Special Bulletin

SP13-326B

TITLE: STRUCTURAL REINFORCEMENT BI-FOLD DOOR AFT CYLINDER SUPPORT
Prevost vehicles

Figure 5

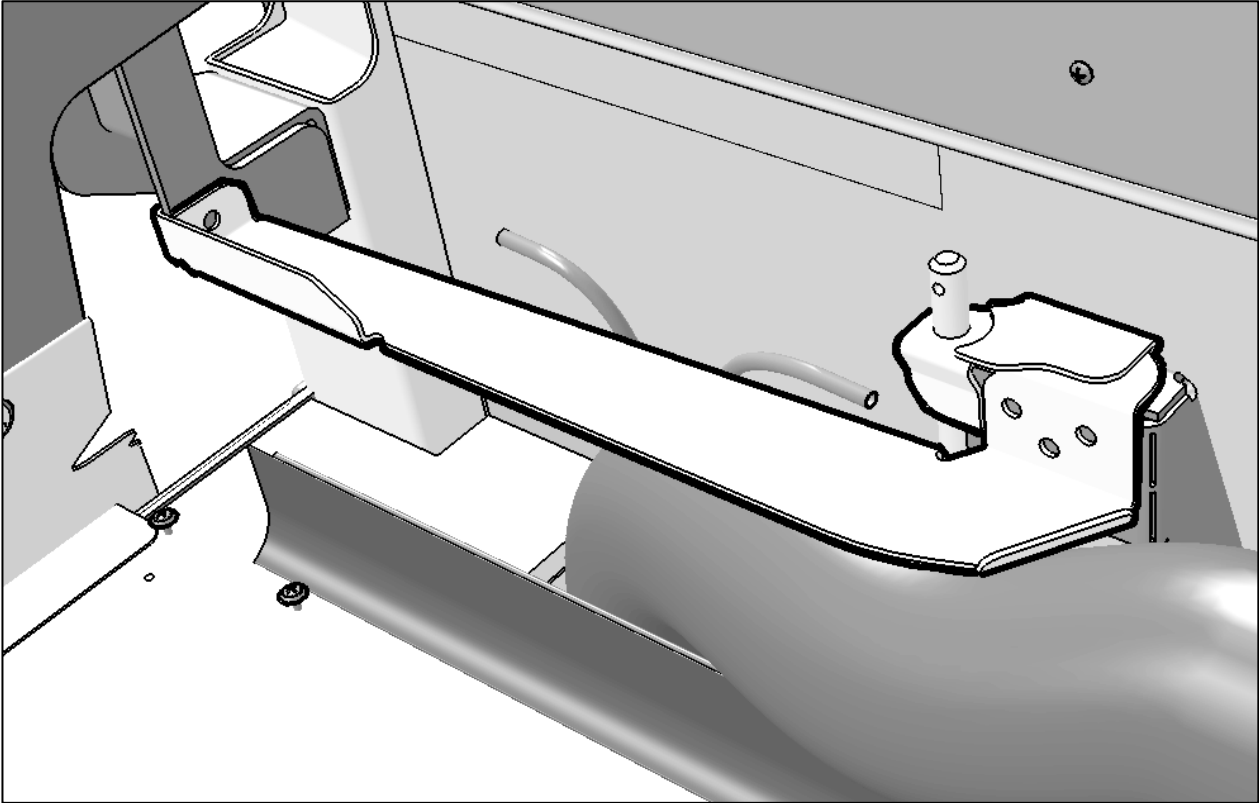
7. Position the structural reinforcement part as shown. Slip the reinforcement over the cylinder anchor pin.(Fig. 5)

Figure 6

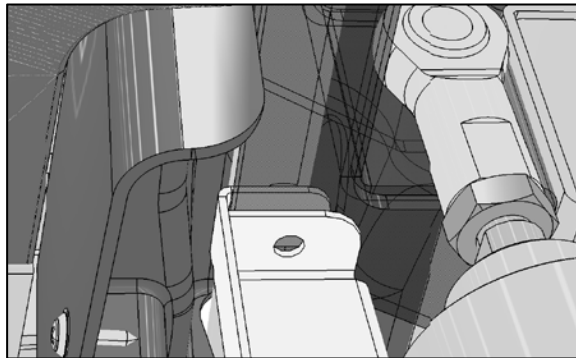
8. The front connection makes a "sandwich".

The two tabs on the part should be slipped in front & behind the vertical structure in this location. (Fig. 6)

Figure 7

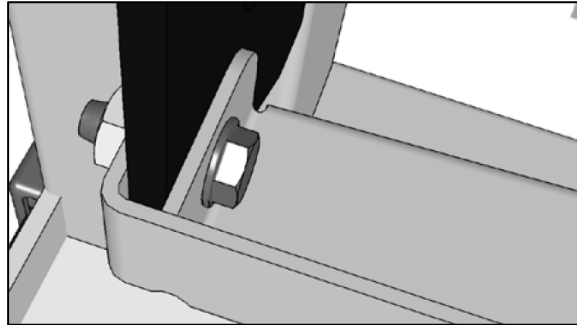
- Drill a 9/32" hole.
- Install the fore screw & nut with #680038 Blue Loctite 243. (Fig. 7)
- Tighten to 70 lbf-in dry (6 lbf-ft dry).
- Mark with torque seal

Figure 8

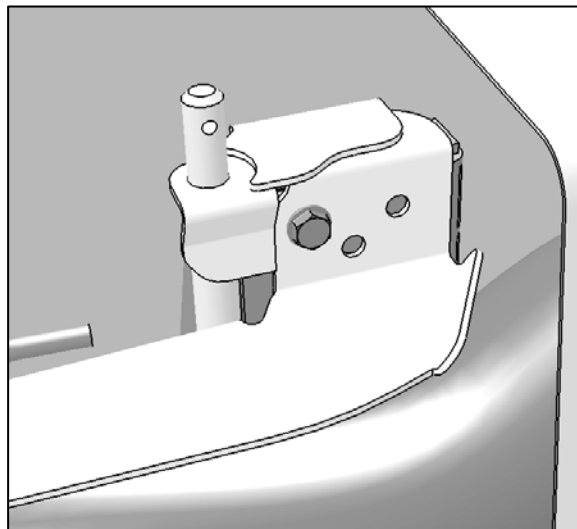
10. Change the drill bit to a smaller-size 7/32" drill.

- With the front end installed, drill a first hole using the part as a template. (Fig. 8)
- Install screw with blue Loctite, hand tighten to about 60 lbf-in dry (5 lbf-ft dry) Hole should be in a clean, dry condition prior to screwing.
- Drill the remaining holes and tighten with blue Loctite to about 60 lbf-in dry (5 lbf-ft dry). Holes should be in a clean, dry condition prior to screwing.
- Mark screws with torque seal.
